REFERENCE:	Nova Bus Manuals
SECTION:	01: Body
RS N°:	MQR 7621-2373
EFFECTIVE IN PROD.:	LE16 (2022MR)

SUBJECT:	Roof Fairing Brackets Cracking.
JUSTIFICATION:	Introduction of a new roof fairing bracket

Figure 1 - Bracket Location (Typical on Both Side)

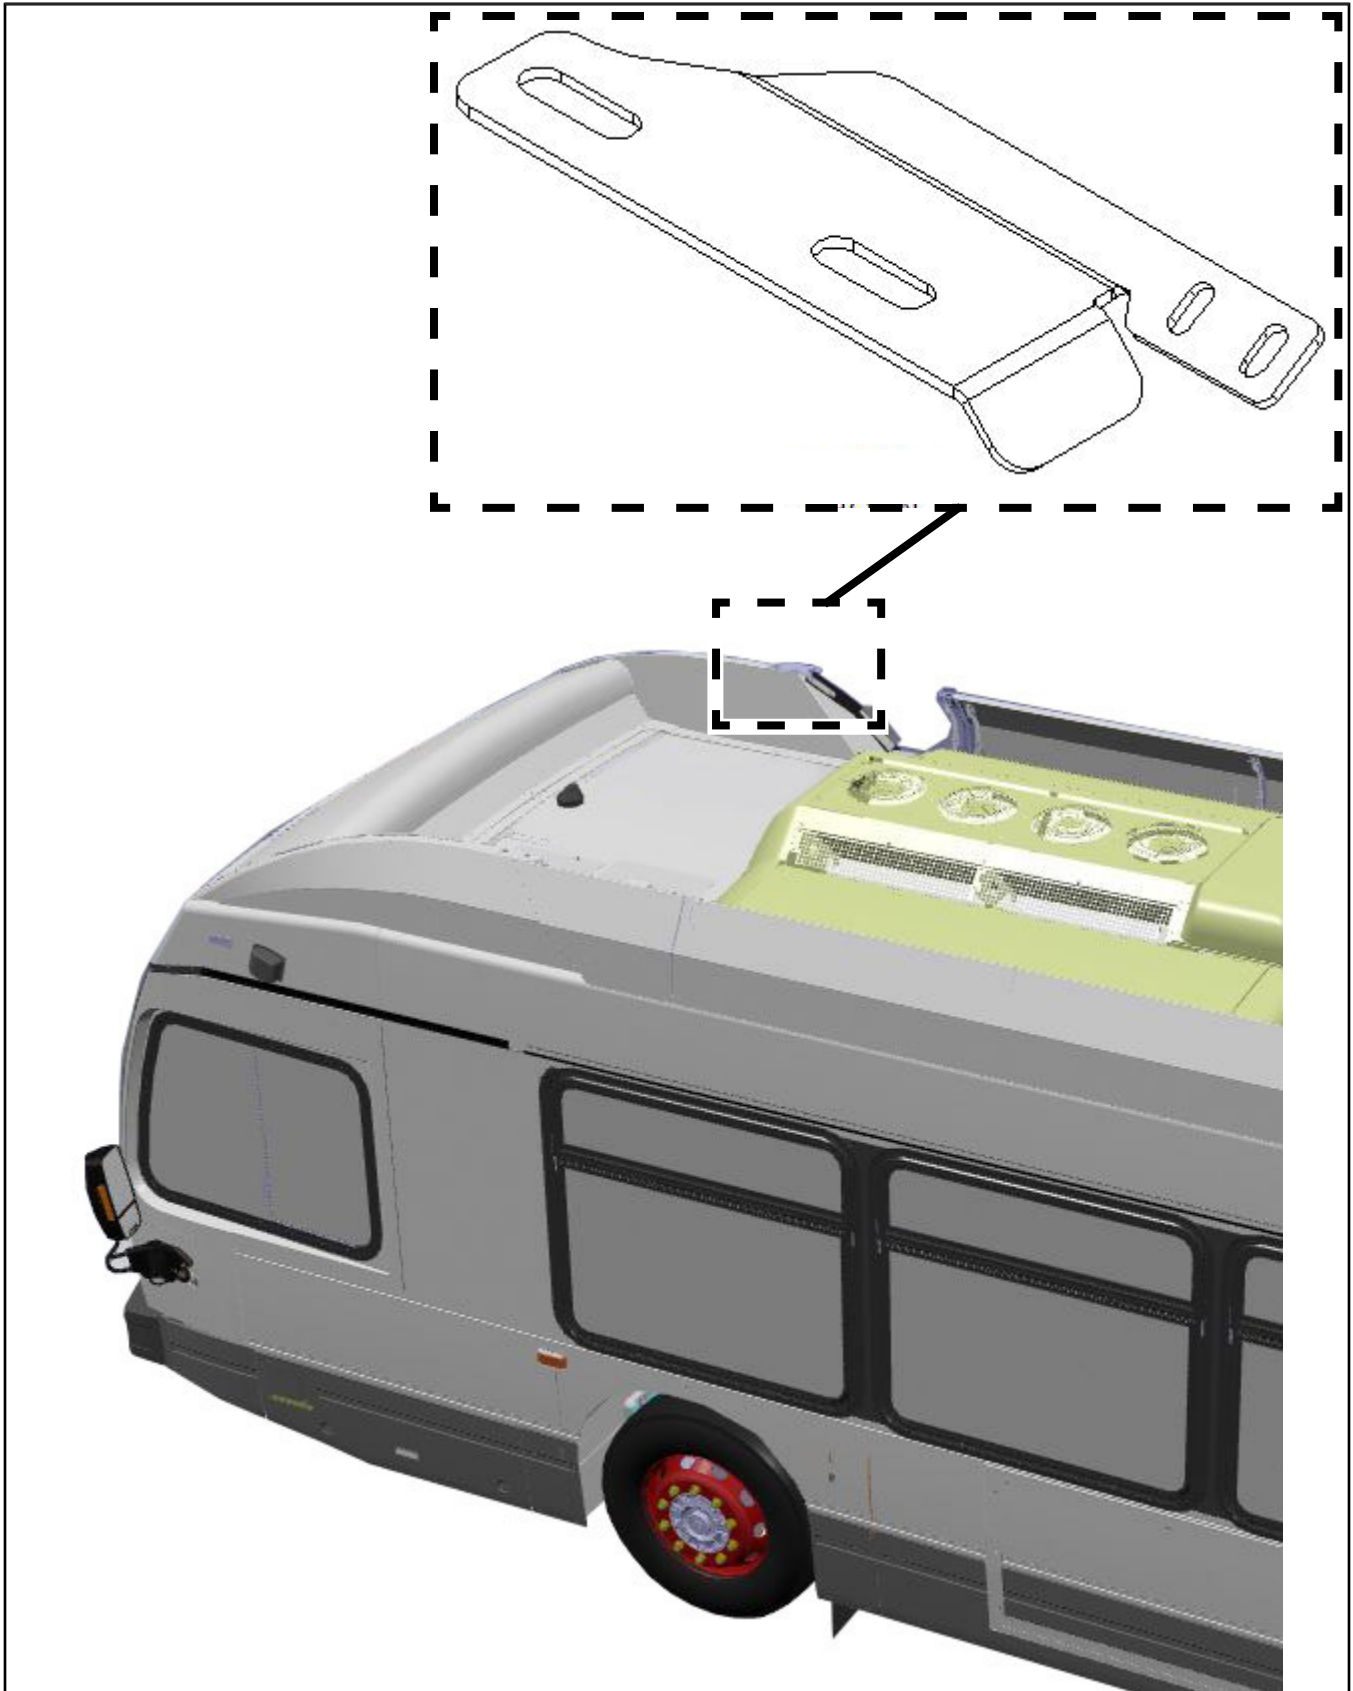
- 1.4. Remove the original roof fairing bracket (see figure 1).
- 1.5. Install the new bracket and hardware (see figure 2).
- 1.6. Apply thread locker N97665 or equivalent. Torque to 6 lb-ft (8 N•m).
- 1.7. Repeat for the other side.
- 1.8. Return the bus to service.
